STAFF REPORT 6-26-2019 MEETING

APPLICATION NUMBER 19-6255

ADDRESS: 671 EDISON

HISTORIC DISTRICT: BOSTON - EDISON

671 Edison, Applicant Photo- Porch Current

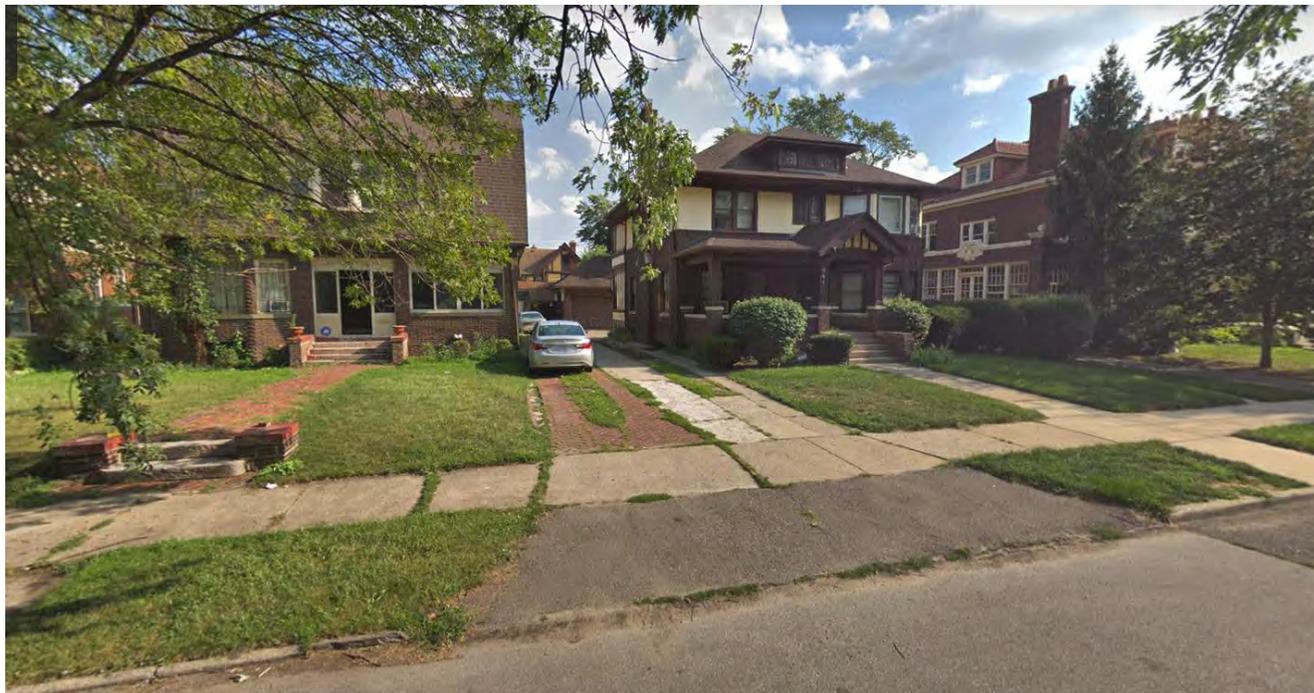
While the applicant has proposed a change in material for the porch and "columns," this alteration from concrete to brick does not destroy historic materials that characterize the property. Wing walls of brick construction can be found on the two homes immediately east of 671 Edison, while the two homes immediately west of 671 have concrete wing walls ([Google streetview images included at the end this report](#)).

It is staff's recommendation that the Commission issue a Certificate of Appropriateness for the proposed work based on the Secretary of the Interior's Standards for Rehabilitation Number 9) *New additions, exterior alterations, or related new construction shall not destroy historic materials that characterize the property. The new work shall be differentiated from the old and shall be compatible with the massing, size scale and architectural features to protect the historic integrity of the property and its environment.*

...With the condition that The installation of concrete hardscape within local historic districts under the condition that it is not "bright white." Specifically, such concrete must be composed of an exposed aggregate, tinted grey, or finished with a clear or tinted grey curing compound.
